**CLINTON CREEK
ASBESTOS MINE
ABANDONMENT PLAN**

REVIEW REPORT

**PREPARED BY
GEO-ENGINEERING (M.S.T.) LTD.
DECEMBER 1986**

Prepared for:
Northern Affairs Program
Whitehorse, Y.T.

CLIENT NORTHERN AFFAIRS PROGRAM	CASSIAR ASBESTOS MINE	
	SITE: CLINTON CREEK WASTE DUMP CONCEPTUAL STABILIZATION MEASURES	
	SCALE: AS SHOWN	PROJECT No: 6 052 2
		FIGURE 3

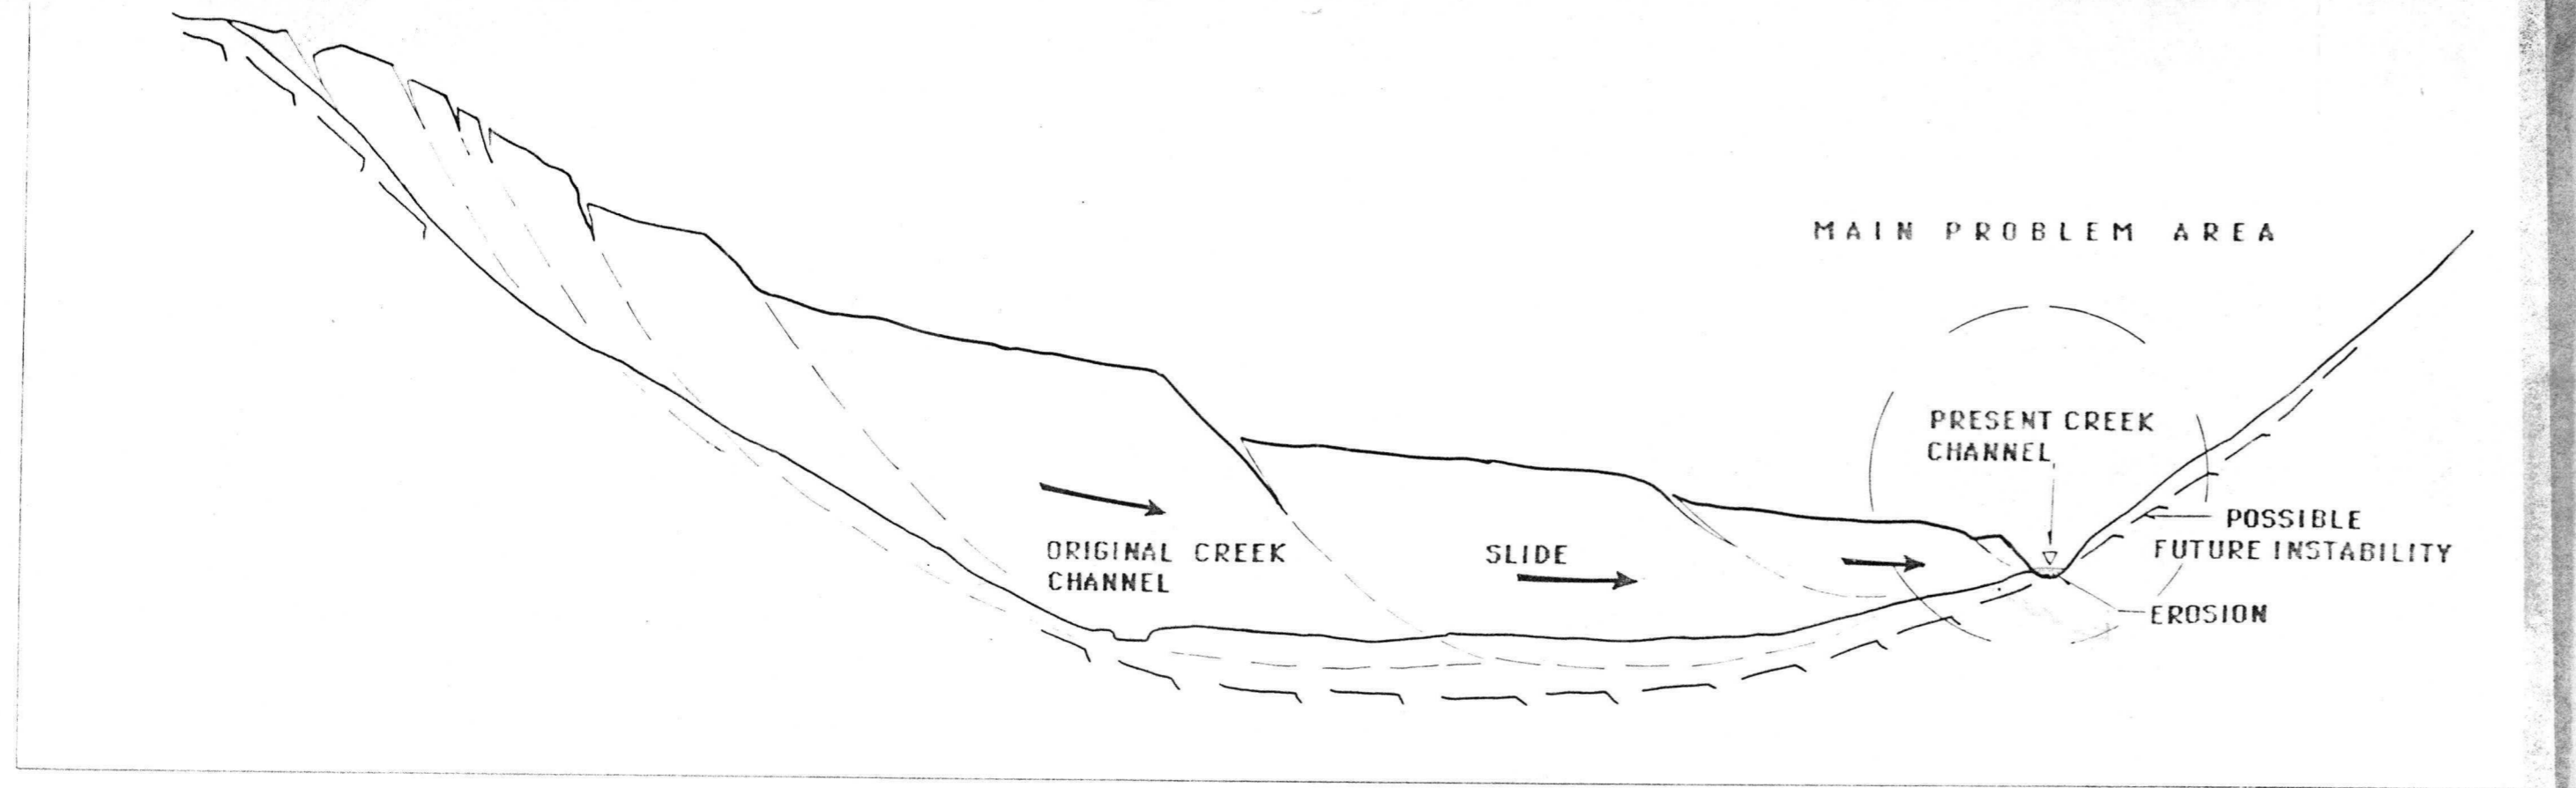
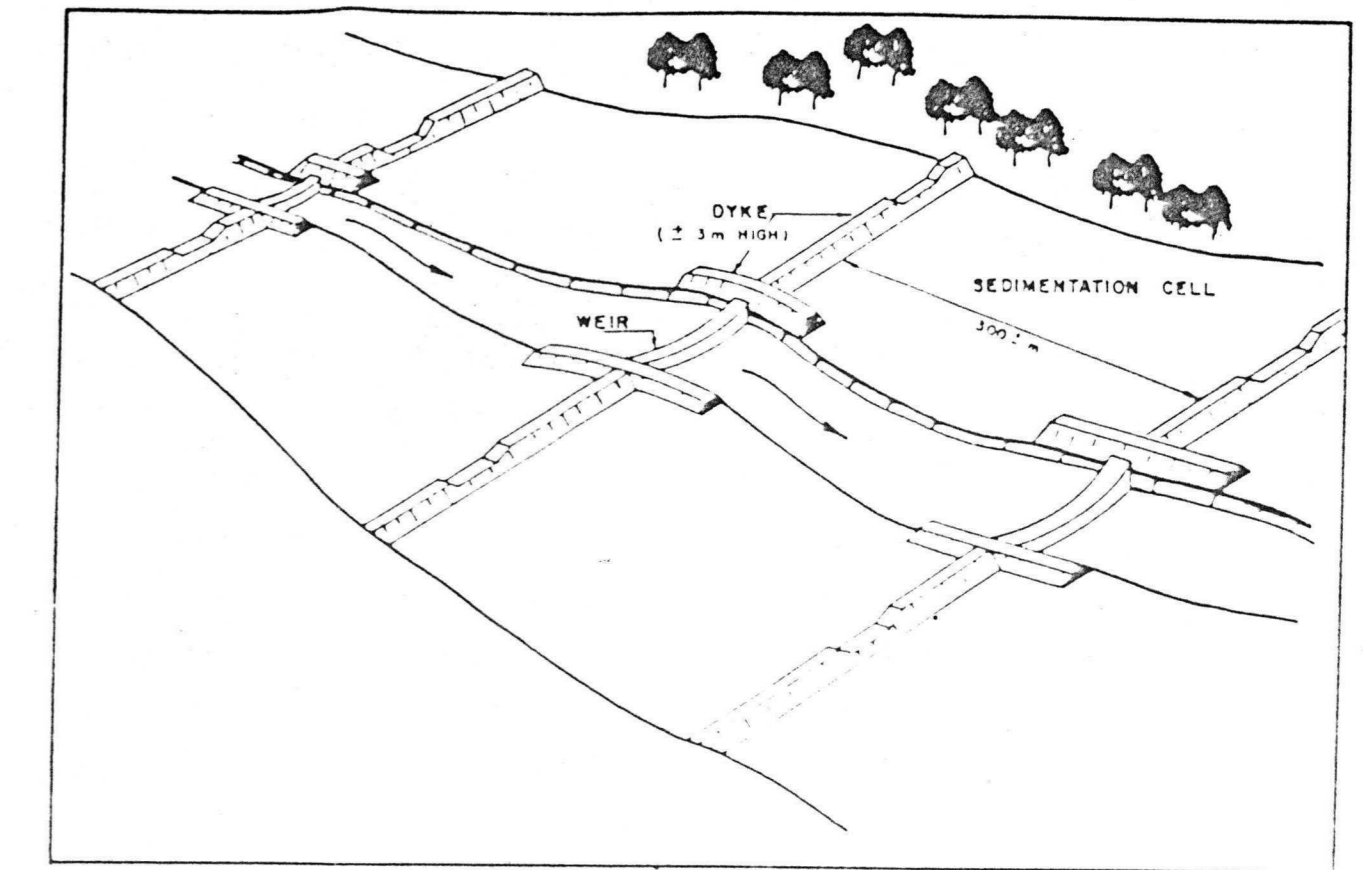
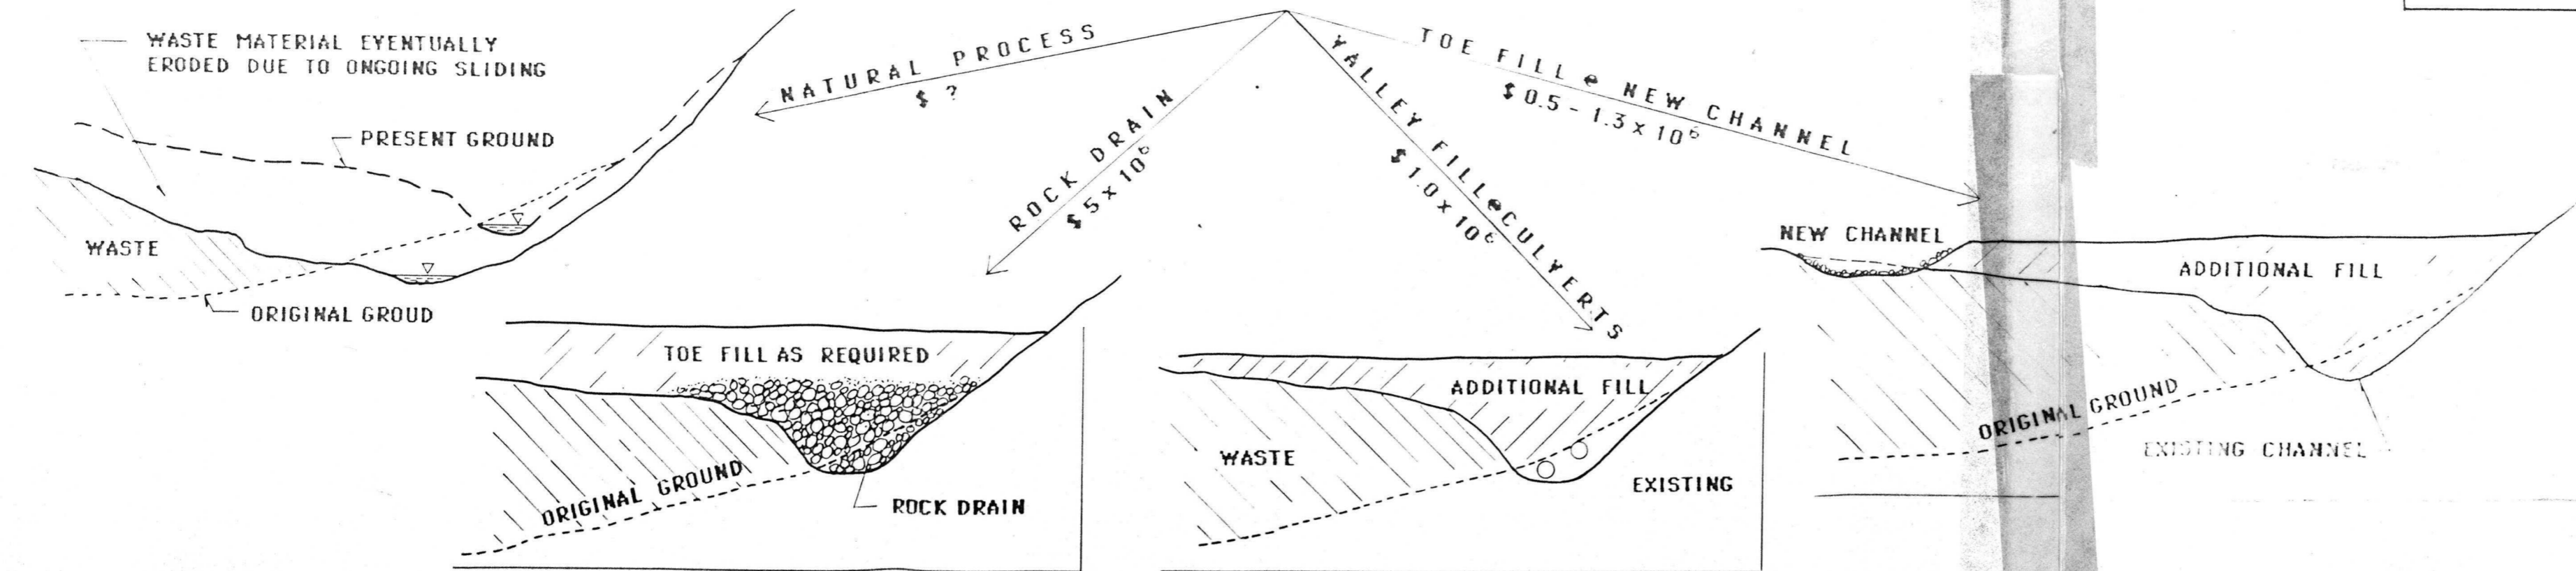
The stabilization measures considered for the dump were evaluated, on a conceptual basis, and are summarized in Table 1. The concepts are also outlined on Figure 8. It is obvious that the stabilization of the dump could only be achieved if the dump toe is buttressed against the opposite valley wall and the flow is safely conveyed across the dump. The estimated costs of such a stabilization, in 1986 dollars, could exceed \$1 million. In addition, maintenance of the diversion channel will likely be required for a certain period of time.

CLIENT NORTHERN AFFAIRS PROGRAM	CASSIAR ASBESTOS MINE	
	TITLE WOLYERINE CREEK TAILINGS PILE CONCEPTUAL STABILIZATION MEASURES	
	SCALE AS SHOWN	PROJECT No. G052-2
		FIGURE 9

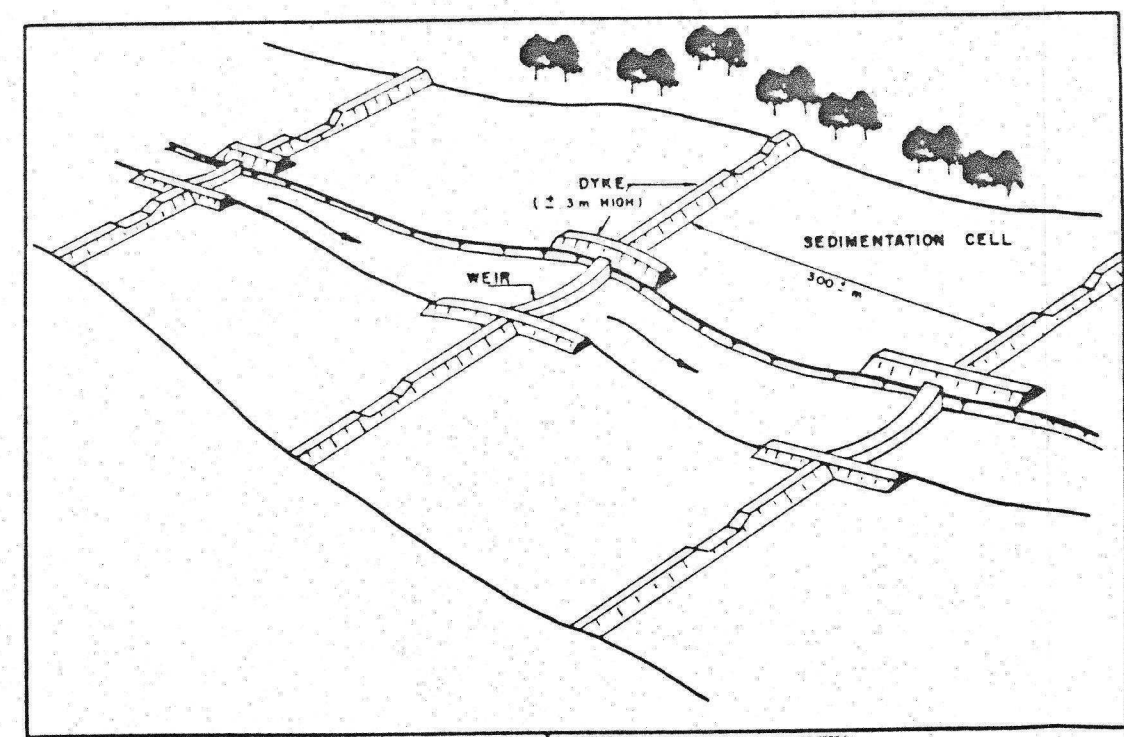
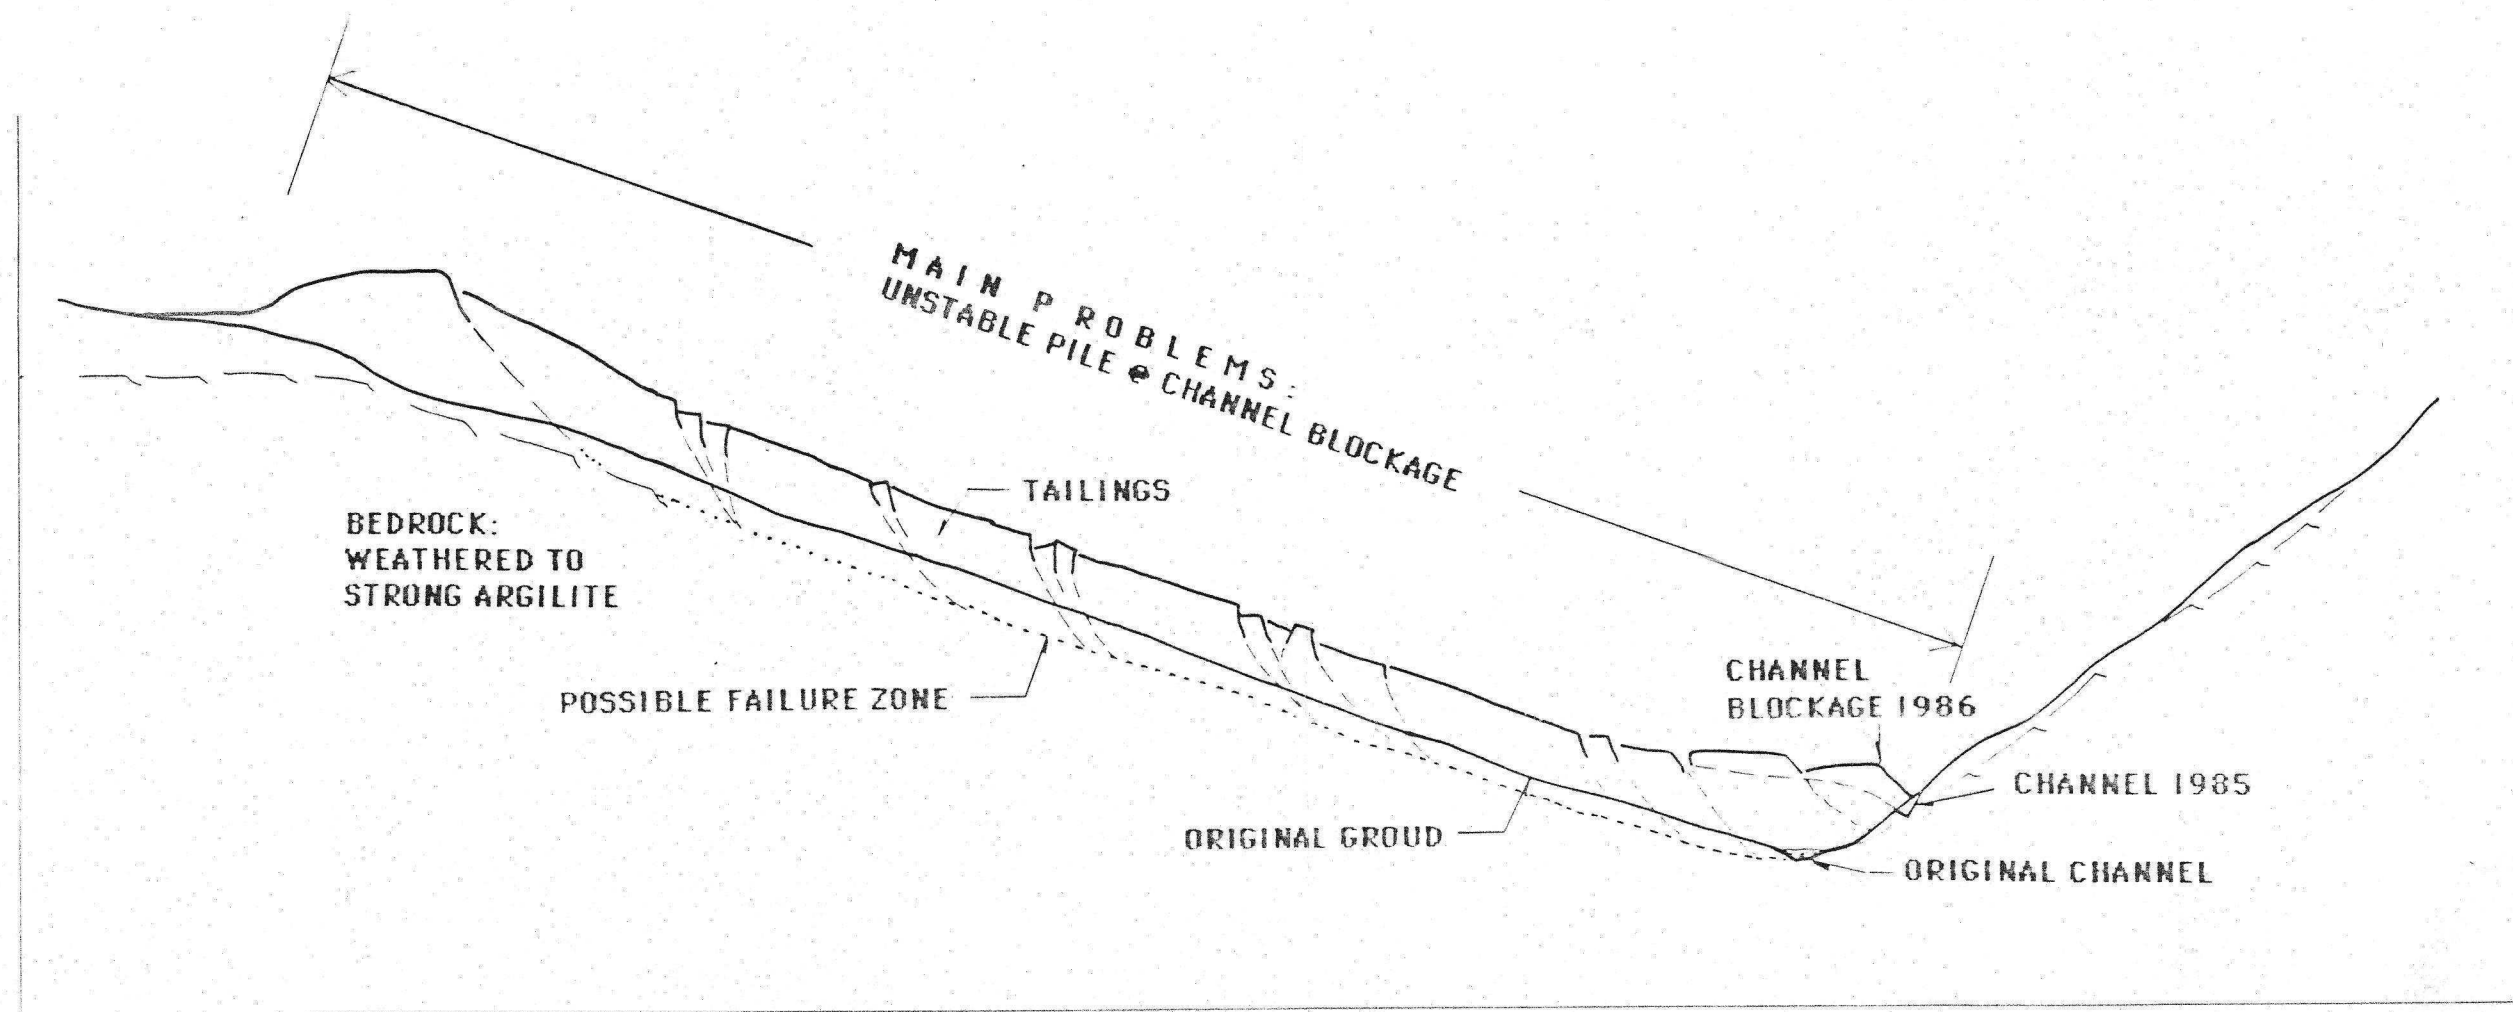
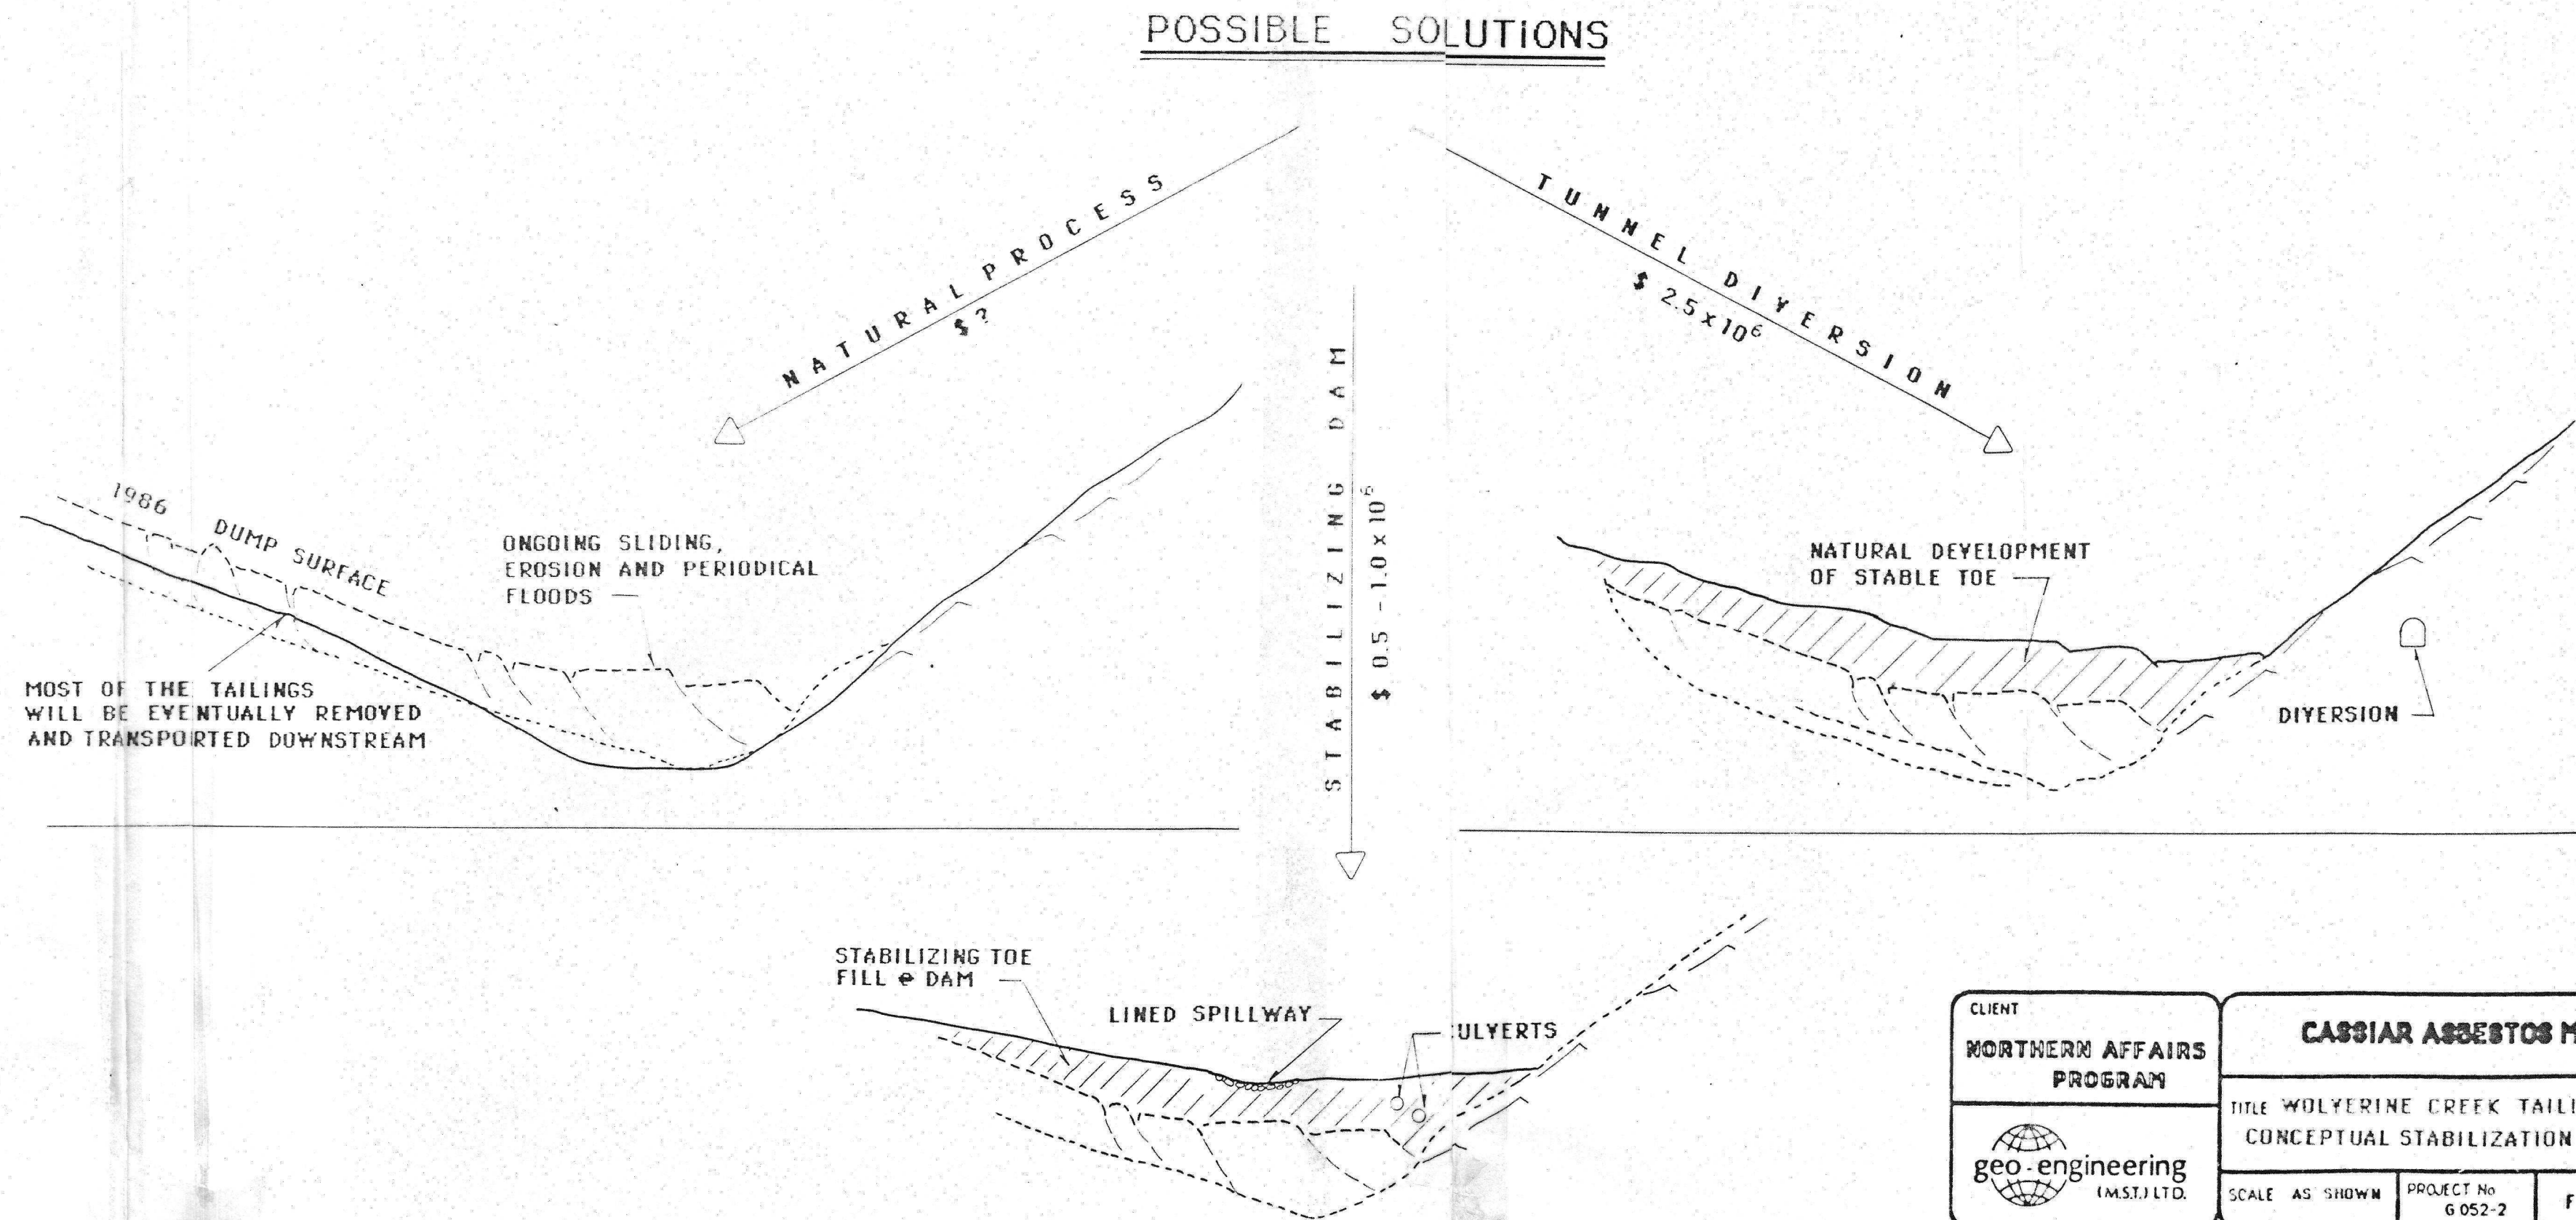
It would be quite difficult to stabilize this embankment. However, several options were evaluated during the past years and the results are summarized on Table 2 and illustrated on Figure 9.
